ORDINANCE NO. 8086

AN ORDINANCE OF THE CITY COUNCIL OF THE CITY OF AMARILLO, TEXAS: AMENDING THE MUNICIPAL CODE OF THE CITY OF AMARILLO, CHAPTER 4-3, ARTICLE III, SECTION 4-3-31 TO ADOPT THE 2021 EDITION OF THE *INTERNATIONAL RESIDENTIAL CODE*, REGULATING AND GOVERNING THE CONSTRUCTION, ALTERATION, MOVEMENT, ENLARGEMENT, REPLACEMENT, REPAIR, EQUIPMENT, LOCATION, REMOVAL AND DEMOLITION OF DETACHED ONE AND TWO FAMILY DWELLINGS AND MULTIPLE SINGLE FAMILY DWELLINGS (TOWNHOUSES) NOT MORE THAN THREE STORIES IN HEIGHT WITH SEPARATE MEANS OF EGRESS IN; PROVIDING FOR THE ISSUANCE OF PERMITS AND COLLECTION OF FEE; PROVIDING FOR SEVERABILITY; PROVIDING FOR REPEALER; PROVIDING FOR CONTINUATION OF PRIOR LAW; PROVIDING A PENALTY; PROVIDING FOR PUBLICATION AND EFFECTIVE DATE.

Figure 602.6.1
TOP PLATE FRAMING TO ACCOMMODATE PIPING

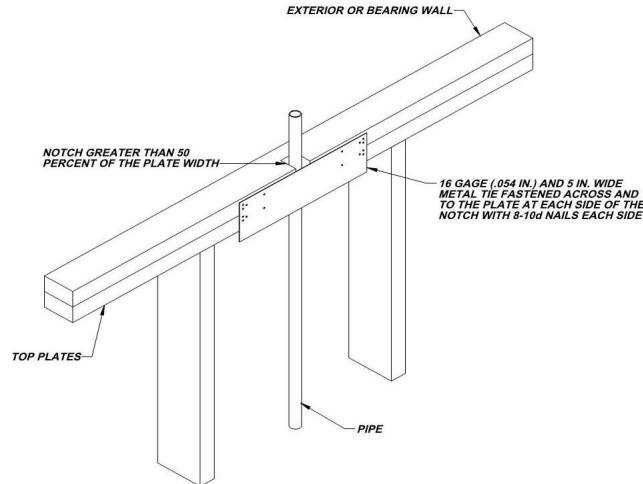
R602.6.1 Drilling and notching of top plate. When piping or ductwork is placed in or partly in an exterior wall or interior load-bearing wall, necessitating cutting, drilling or notching of the top plate by more than 50 percent of its width, a galvanized metal tie not less than 0.054 inch thick (1.37 mm) (16 Ga) and 1 ½ inches (38) mm 5 inches (127 mm) wide shall be fastened across and to the plate at each side of the opening with not less than eight 10d (0.148 inch diameter) ~~nails having a minimum length of 1½ inches (38 mm) or eight (#10) wood screws having a minimum length of not less than 1½ inch (38 mm)~~ at each side or equivalent as approved by the Code Official. Fasteners will be offset to prevent splitting of the top plate material. The metal tie must extend a minimum of 6 inches past the opening. See figure R602.6.1. {Remainder unchanged}

908.3.1.1 HAIL EXPOSURE FIGURE MAP

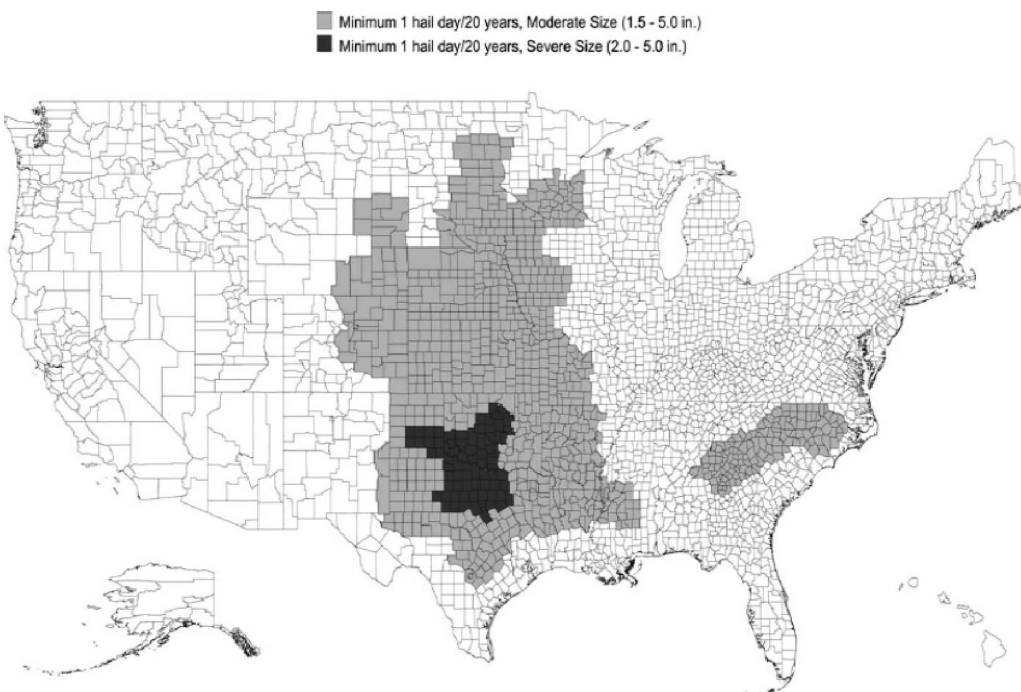
R908.3.1.1. A roof re-cover shall not be permitted where any of the following conditions occur:

1. Where the existing roof or roof covering is water-soaked or has deteriorated to the point that the existing roof or roof covering is not adequate as a base for additional roofing.
2. Where the existing roof covering is wood, slate, clay, cement or asbestos-cement tile.
3. Where the existing roof has two or more applications of any type of roof covering.
4. For asphalt shingles, when the building is located in an area subject to moderate or severe hail exposure according to Figure R908.3.1.1.
